Update the report to a Final Drainage Report. See Chapter 4 of the DCM for report guideline.

RE: Drainage Letter for Dancing Wolf Estates Replat (EA-16-128)

Add PCD File No. PUD-18-002
& VR-18-002

Cross Section for Trapezoidal Channel - 1 from 83 to north 100 yr flow

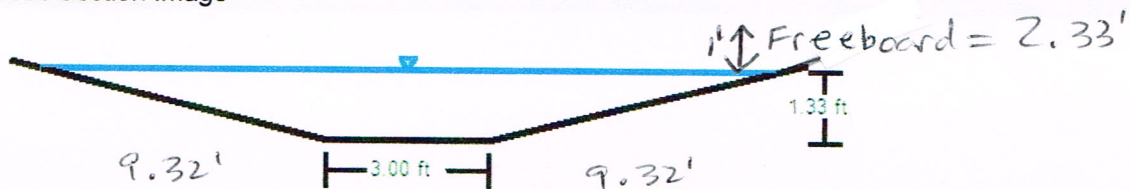
This is greater than permissible velocities in the Drainage Criteria Manual.

Channel s should be designed for Froude numbers less than 0.9.

Cross Section for Trapezoidal Channel - 2 after confluence from 2-48s

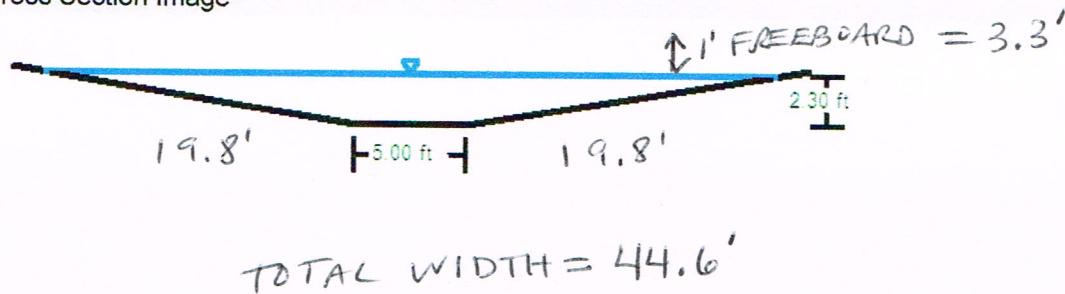
Include as design points on the drainage map so it is clear.

Provide the calculation on how this combined flow rate was derived

This is greater than permissible velocities in the Drainage Criteria Manual.
